METROPOLITAN GOVERNMENT OF NASHVILLE AND DAVIDSON COUNTY

STAFF RECOMMENDATION 112 Mockingbird Road January 21, 2015

Application: New construction—addition and outbuilding
District: Cherokee Park Neighborhood Conservation Zoning Overlay
Council District: 24
Map and Parcel Number: 10312024200
Applicant: Matt Smith, Haury & Smith Contractors
Project Lead: Paul Hoffman, paul.hoffman@nashville.gov

Description of Project: The applicant proposes construction of an addition to the rear of the home, and an addition to the existing garage. The applicant has stated that no portion of the outbuilding will be used as a dwelling.

Figure 2. The covered portion connecting the addition to the outbuilding is highlighted. Staff is recommending this portion be removed from the project.

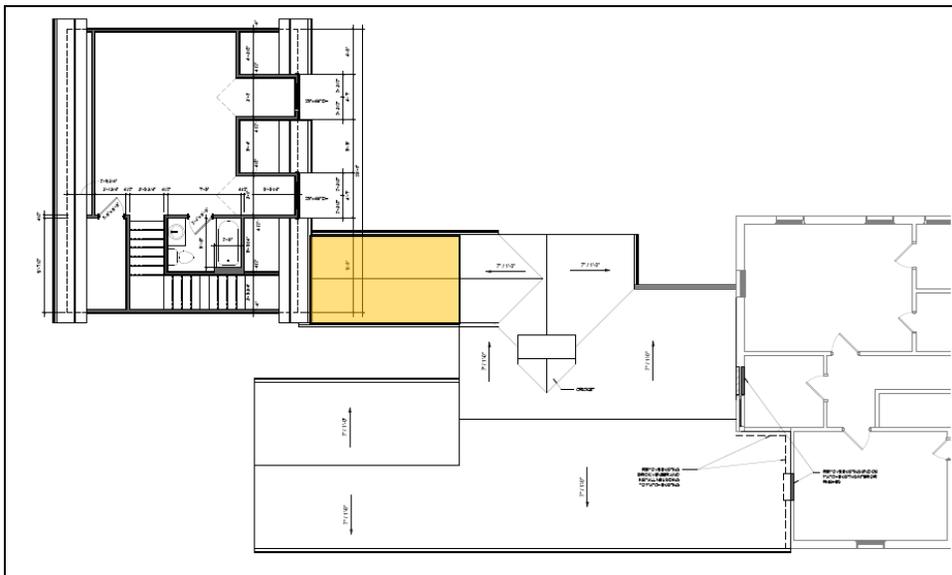
The drawings include a covered walkway, connecting the existing house and addition to the outbuilding (see Figure 2). Narrow connectors have been approved in the past; however, this one connects to a long porch that continues to the house which is actually creating a long and wide connection. The Commission has not found this much of a connector appropriate in the past because it is not an historic condition. Staff recommends removal of the covered portion connecting the addition to the outbuilding.

1. The covered walkway connecting the addition to the outbuilding be removed;
2. The addition set in at least one foot (1') where it meets the left side of the house;
3. Staff approve the final details, dimensions and materials of porch, trim, chimney, windows and doors prior to purchase and installation;
4. Staff approve siding material, and that the siding have a maximum five inch (5") reveal;
5. The wall dormers on the outbuilding be redesigned to roof dormers that sit back from the wall beneath by no less than two feet (2').

FIRST FLOOR - PROPOSED
Scale: 1/4"=1'-0"

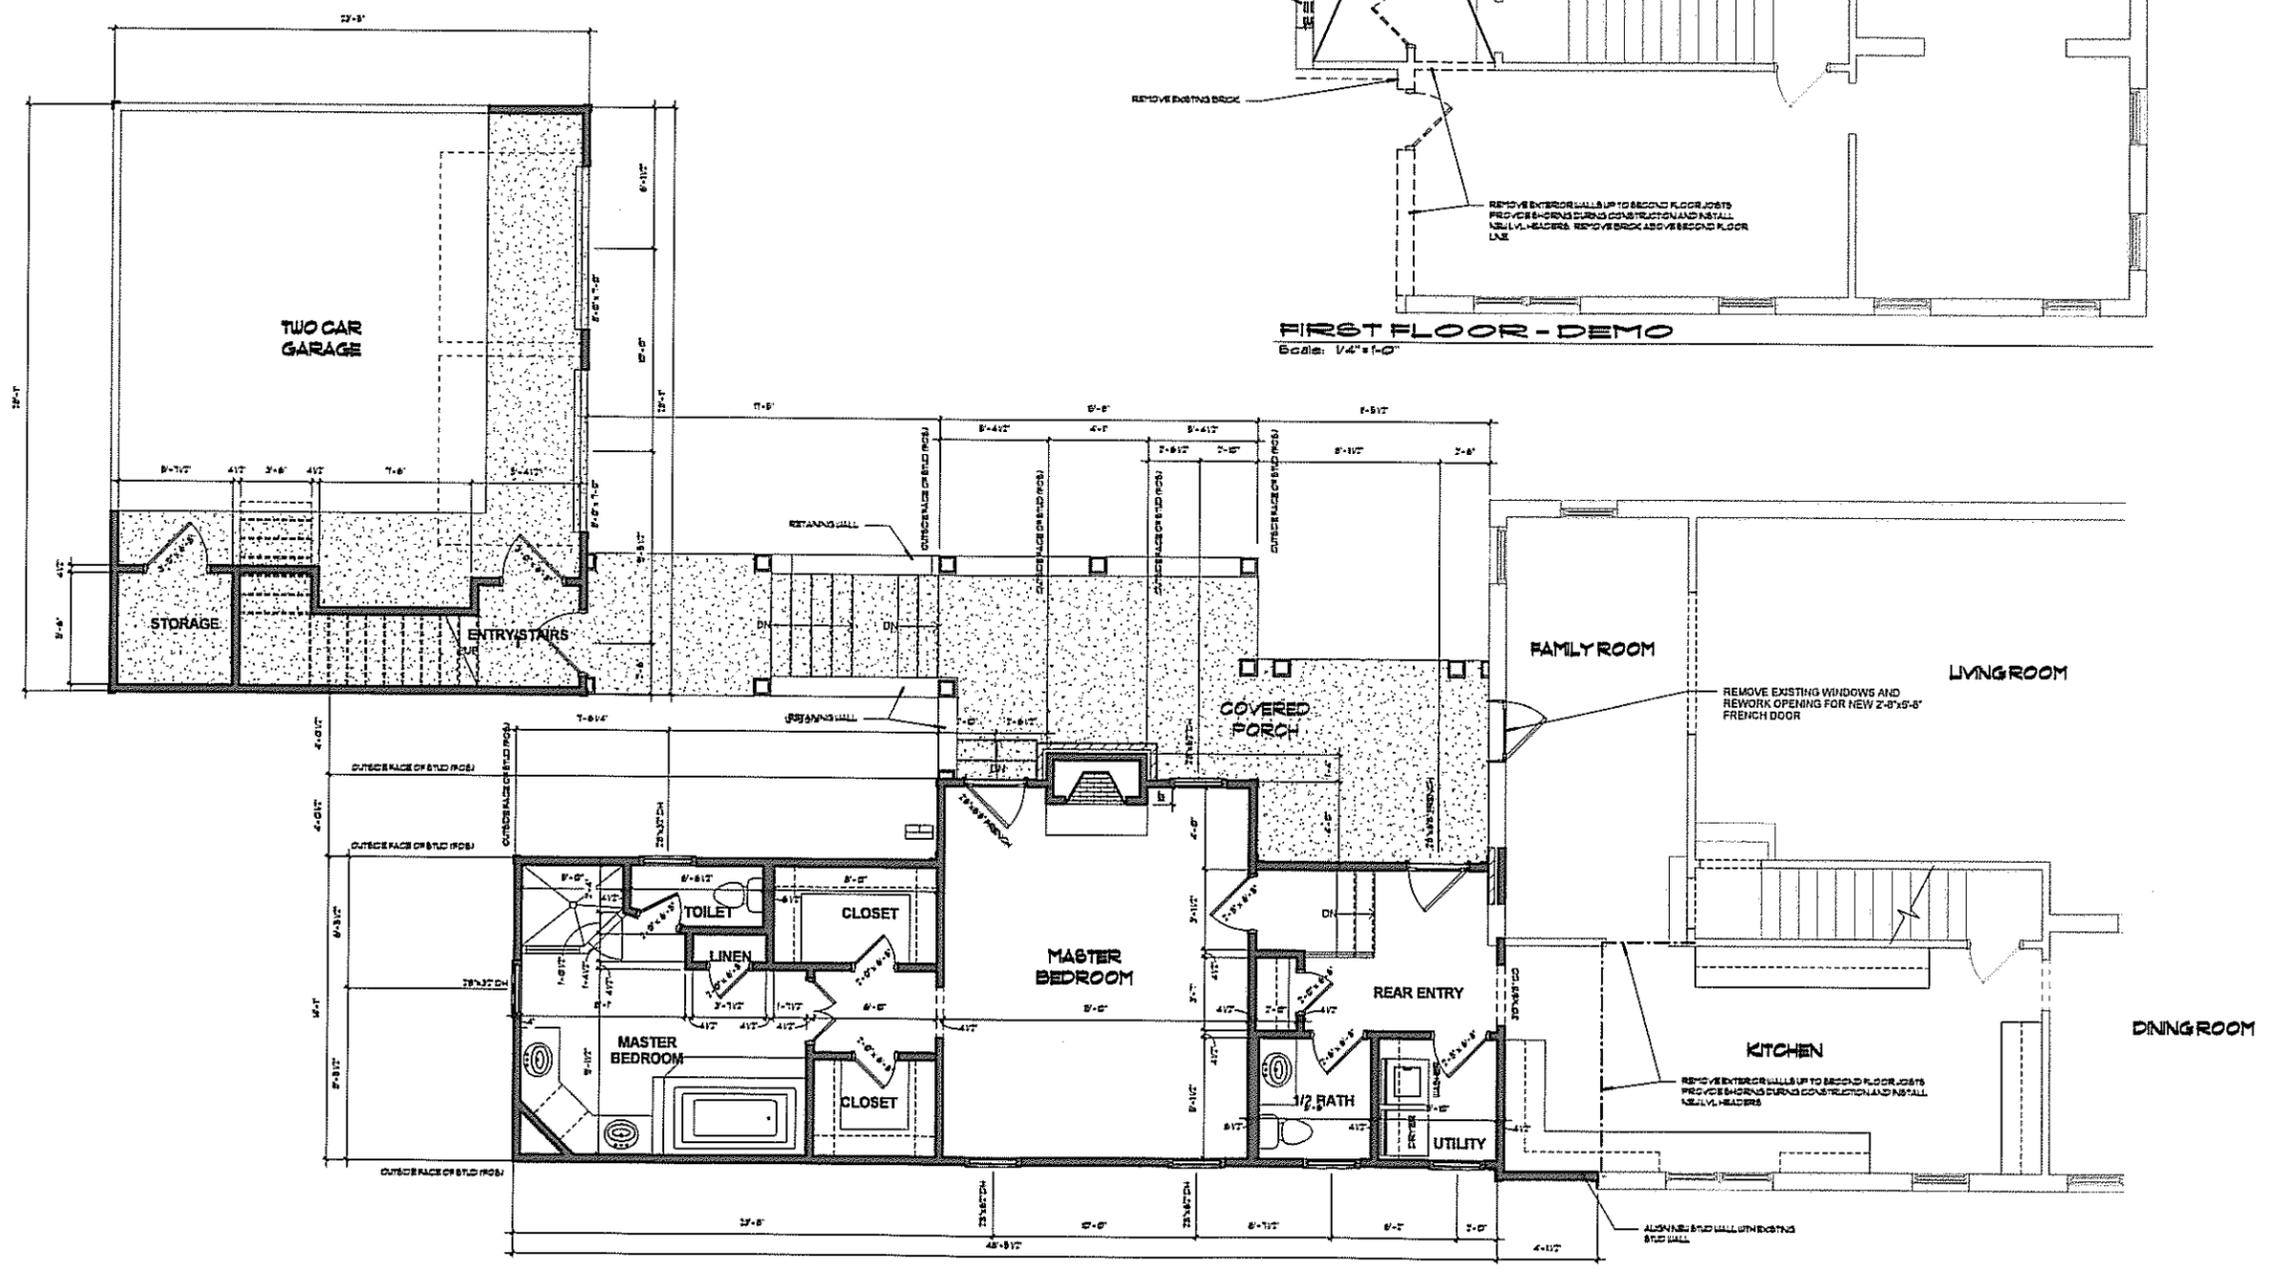
Location & Removability: The addition's location at the rear is in accordance with the design guidelines. It will inset eighteen feet (18') from the right side of the house. On the left side, although there is a material change from brick to siding, there is not sufficient inset allowed for. Staff requests a one foot (1') inset to distinguish the addition from the existing house, in accordance with the design guidelines.

LEFT SIDE ELEVATION
Scale: 1/4"=1'-0"

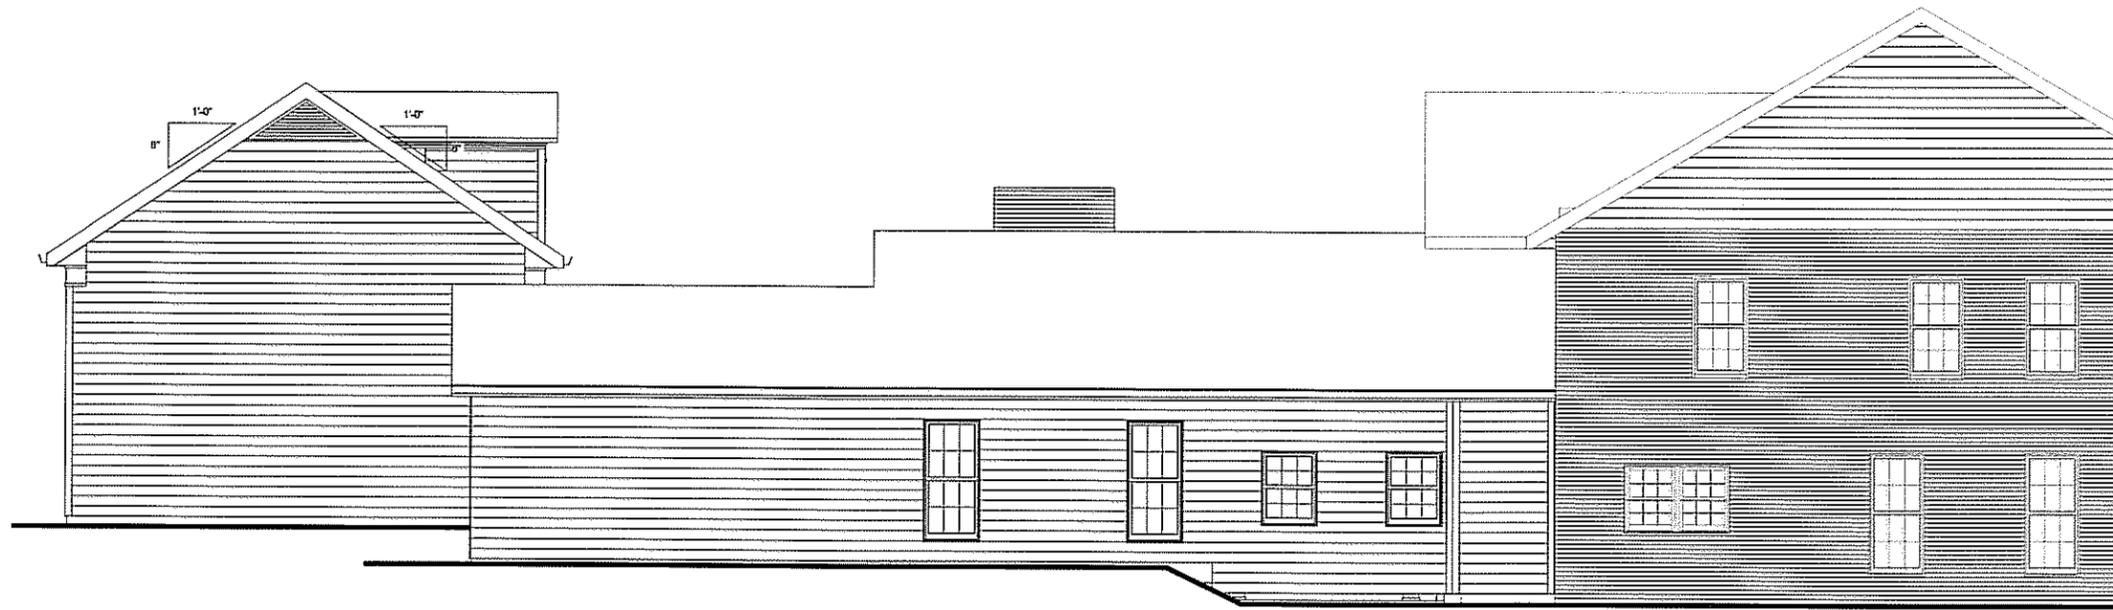
Proportion and Rhythm of Openings: The windows on the proposed addition are generally twice as tall as they are wide, meeting the historic proportion of openings. There is an expanse of twenty-two feet (22') without an opening on the addition's left

side. This is at the rear of the addition, and will be less than ten feet (10') from the neighboring home when constructed. Since this portion will be minimally visible, Staff finds the addition's proportion and rhythm of openings meets Section II.B.1.g.

SHEET #
A103

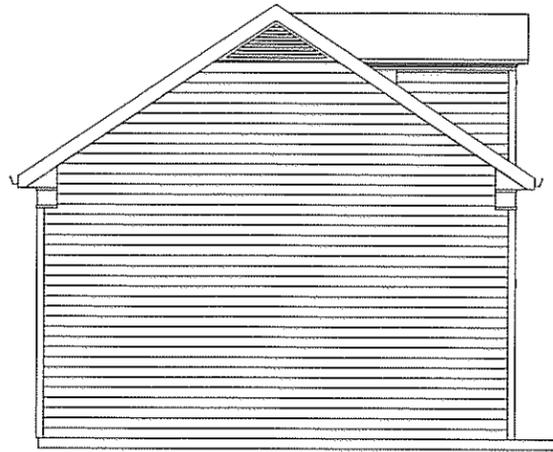
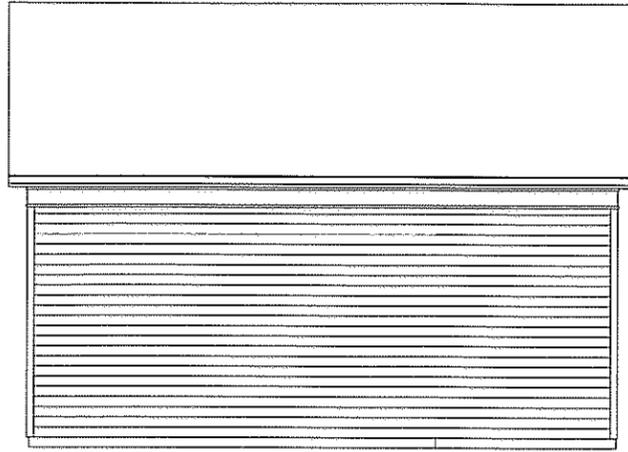
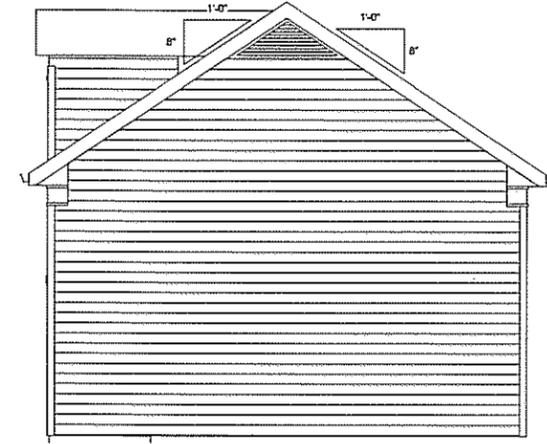
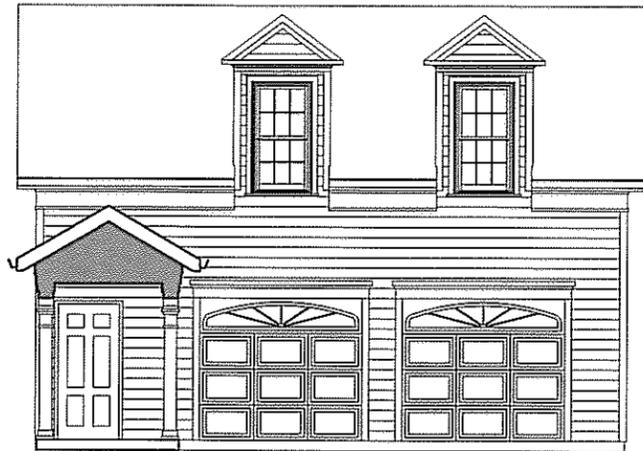
Roof: The current design features two wall dormers that stack directly on the wall. Staff requests the dormers sit back from the exterior wall by no less than two feet (2') to meet the design guidelines. Wall dormers are generally not seen historically in this neighborhood and accentuate the massing.
